Working paper no: WP\_0050

Title: Dustin Hardware Delta's B2.1-2 to B2.1-5

The changes are detailed in the form of ECR's (Engineering Change Requests).

| <b>Confirmed By:</b>   | <b>Date:</b>                   |
|------------------------|--------------------------------|
| <b>Project:</b> Dustin | <b>ECR Ref:</b> Dustin_ECR_191 |

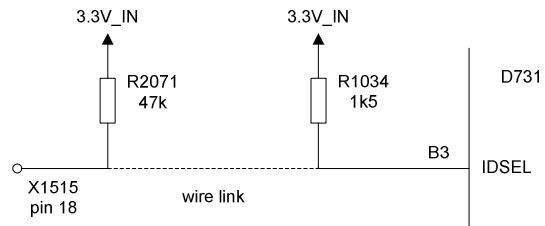
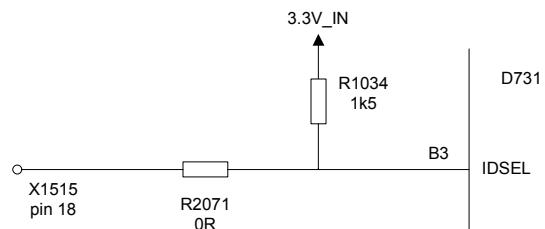
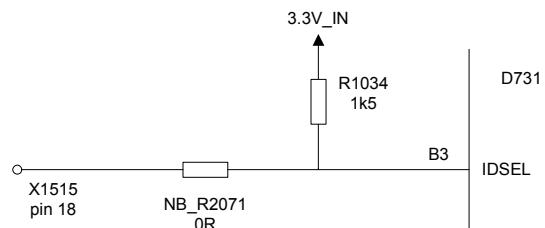
| <b>Item Description:</b> Connect IDSEL line on the NEC USB Host Controller chip to the Cardbus connector   |                                |                               |
| <b>Reason For Change: (e.g. list of associated Problem Reports)</b><br><br>4G have allocated pin 18 of the Cardbus connector (Vpp1) to the function IDSEL. This pin must therefore be routed to the IDSEL line on the NEC USB Host Controller chip.<br><br>This has no Affect on the Radio Performance.  |                                |                               |

| <b>Details of Change: (e.g. sections of document that have changed)</b><br><br>Disconnect R2071 pin 2 from the net 3.3V_IN and route instead to pin B3 (92) of D731 (NEC µPD720101 USB Host Controller).<br><br>Change R2071 from 47k to 0R 0201<br><br>R2071 is No Build for the PC card Variant and fitted for the Router Variant (Variant A) as shown in the figures on the following page. |                                |                               |

Figure 1: present arrangement

Figure 2: Router variant (variant A): R2071 fitted

Figure 3: PC card variant: R2071 not fitted (NB)
